Mack Chassis - Hood Mirror Vibration - Model AN

A product improvement has been made to the Mack Anthem Hood Mirror. The supplier has reinforced the mirror glass carrier backing to make it more robust by filling in the tabs as seen below. The component material has changed from ASA to ABS plastic. This improvement affects Mack Anthem trucks, built from January 1, 2018 thru May 24, 2021.

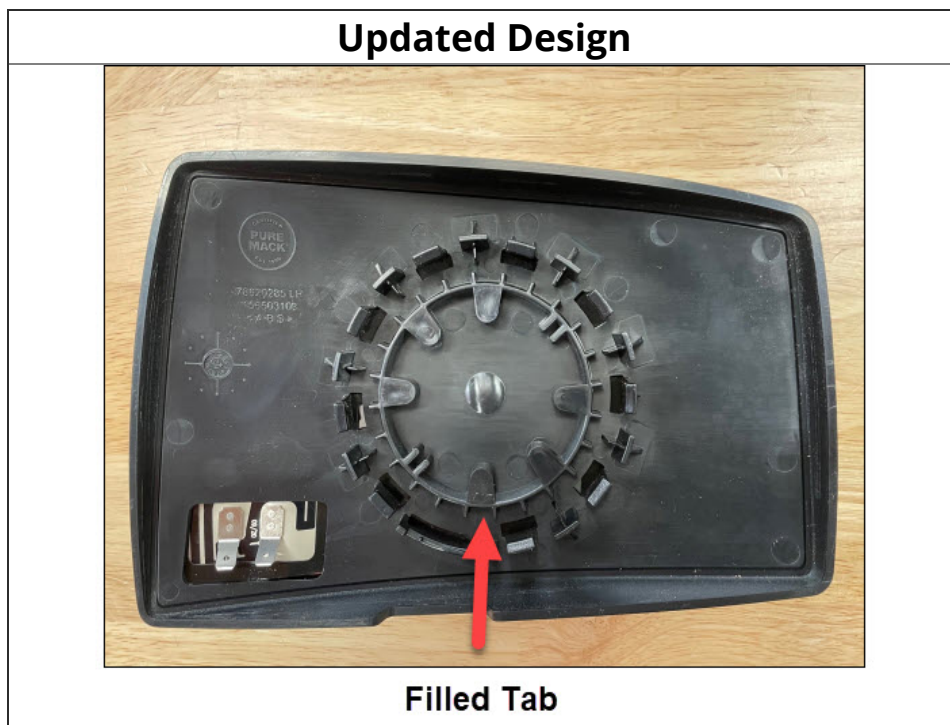
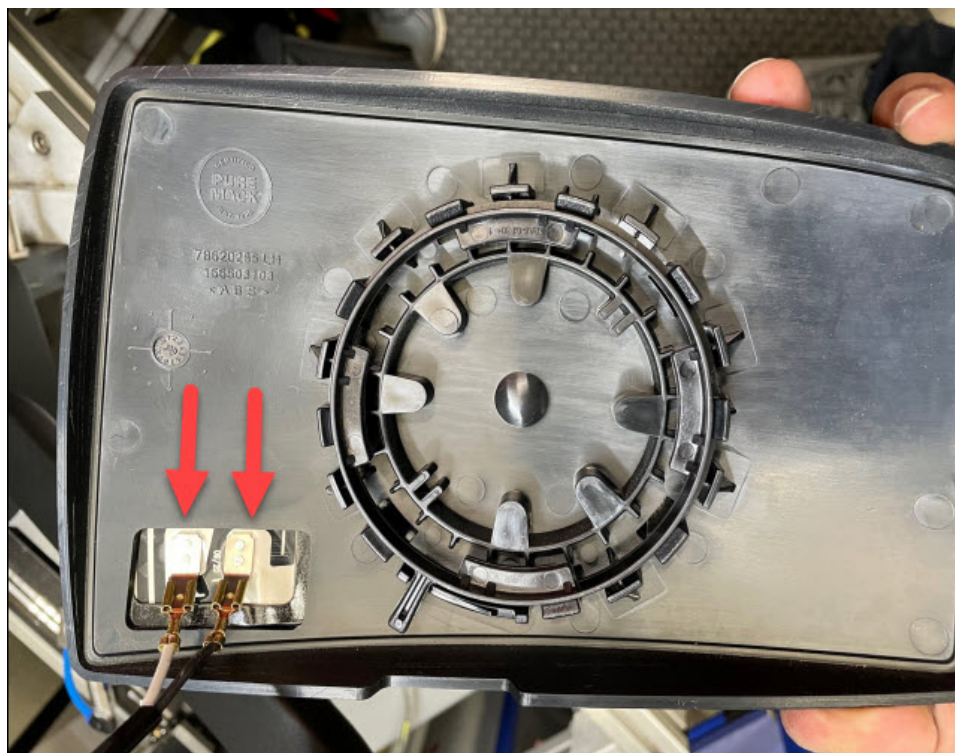
NOTE: All mirror glass carrier assemblies are manufactured as heated. If the truck does not have the heated mirror option, simply ignore the electrical contacts. See the electrical contacts in the illustration below.

Previous Assembly	
P/N	Description
78620286	LH Unheated Assembly
78620287	LH Heated Assembly
78620288	RH Unheated Assembly
78620291	RH Heated Assembly

Updated Assembly	
P/N	Description
78620290	RH Heated Assembly
78620285	LH Heated Assembly
